## PRODUCT CHANGE NOTIFICATION (PCN)

### A-MCSP-80300 MODULAR CABLE

CHANGE NOTIFICATION: PCN 20220425\_A-MCSP-80300

ASSMANN WSW P/N	Drawing Number		ASSMANN WSW P/N	Drawing Number
A-MCSP-80300	ASS_7425_CArev06	↔	A-MCSP-80300	ASS_7425_CArev07

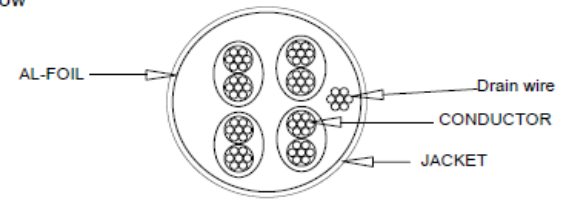
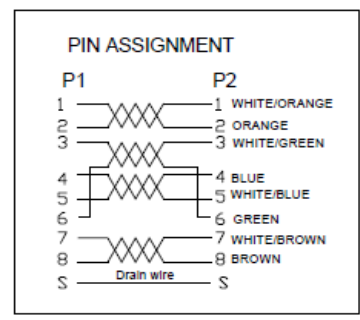
DESCRIPTION OF CHANGES: CHANGE OF DATA SHEET  
CHANGE OF DATA SHEET  
New Draw.-No. ASS\_7425\_CArev07

REASON FOR CHANGE: CHANGE OF PRODUCT LOCATION  
CHANGE OF PRODUCT LOCATION

A-MCSP-80300	OLD VERSION	A-MCSP-80300	NEW VERSION																																																	
<p>Appearance</p>		<p>Appearance</p>																																																		
<p>BOM</p> <table border="1"> <thead> <tr> <th>NO</th> <th>PART NO</th> <th>DESCRIPTION</th> <th>QTY</th> <th>UNIT</th> </tr> </thead> <tbody> <tr> <td>3</td> <td>mold</td> <td>PVC,50P</td> <td>9.0</td> <td>G</td> </tr> <tr> <td>2</td> <td>plug</td> <td>8P8C plating gold 3U* with metal shield</td> <td>2</td> <td>PCS</td> </tr> <tr> <td>⑤ 1</td> <td>cable</td> <td>FTP (26AWG*1P)*4+D+A+PVC, OD:5.2±0.2mm CAT5E</td> <td>2.0</td> <td>M</td> </tr> </tbody> </table>		NO	PART NO	DESCRIPTION	QTY	UNIT	3	mold	PVC,50P	9.0	G	2	plug	8P8C plating gold 3U* with metal shield	2	PCS	⑤ 1	cable	FTP (26AWG*1P)*4+D+A+PVC, OD:5.2±0.2mm CAT5E	2.0	M	<p>BOM</p> <table border="1"> <thead> <tr> <th>NO</th> <th>PART NO</th> <th>DESCRIPTION</th> <th>QTY</th> <th>UNIT</th> </tr> </thead> <tbody> <tr> <td>⑦</td> <td>⚠</td> <td>AL-Foil</td> <td>Double-sided conductive aluminum foil</td> <td>2</td> <td>PCS</td> </tr> <tr> <td>⑦</td> <td>⚠</td> <td>mold</td> <td>PVC,65P</td> <td>AR</td> <td>G</td> </tr> <tr> <td></td> <td>⚠</td> <td>plug</td> <td>8P8C plating gold 3U* with metal shield</td> <td>2</td> <td>PCS</td> </tr> <tr> <td>⑦⑤</td> <td>⚠</td> <td>cable</td> <td>CAT5E F/UTP (26AWG*1P)*4+D+A+PVC, OD:5.2±0.2mm</td> <td>AR</td> <td>M</td> </tr> </tbody> </table>		NO	PART NO	DESCRIPTION	QTY	UNIT	⑦	⚠	AL-Foil	Double-sided conductive aluminum foil	2	PCS	⑦	⚠	mold	PVC,65P	AR	G		⚠	plug	8P8C plating gold 3U* with metal shield	2	PCS	⑦⑤	⚠	cable	CAT5E F/UTP (26AWG*1P)*4+D+A+PVC, OD:5.2±0.2mm	AR	M

NO	PART NO	DESCRIPTION	QTY	UNIT																																																
3	mold	PVC,50P	9.0	G																																																
2	plug	8P8C plating gold 3U* with metal shield	2	PCS																																																
⑤ 1	cable	FTP (26AWG*1P)*4+D+A+PVC, OD:5.2±0.2mm CAT5E	2.0	M																																																
NO	PART NO	DESCRIPTION	QTY	UNIT																																																
⑦	⚠	AL-Foil	Double-sided conductive aluminum foil	2	PCS																																															
⑦	⚠	mold	PVC,65P	AR	G																																															
	⚠	plug	8P8C plating gold 3U* with metal shield	2	PCS																																															
⑦⑤	⚠	cable	CAT5E F/UTP (26AWG*1P)*4+D+A+PVC, OD:5.2±0.2mm	AR	M																																															
<p>FOR DETAIL, PLEASE TAKE ATTACHED NEW DRAWING: FOR REFERENCE</p>

NO	PART NO	DESCRIPTION	QTY	UNIT
⑦	④	AL-Foil Double-sided conductive aluminum foil	2	PCS
⑦	④	mold PVC,65P	AR	G
⑦	④	plug 8P8C plating gold 3U* with metal shield	2	PCS
⑦⑤	④	cable CAT5E F/UTP (26AWG*1P)*4+D+A+PVC, OD:5.2±0.2mm	AR	M
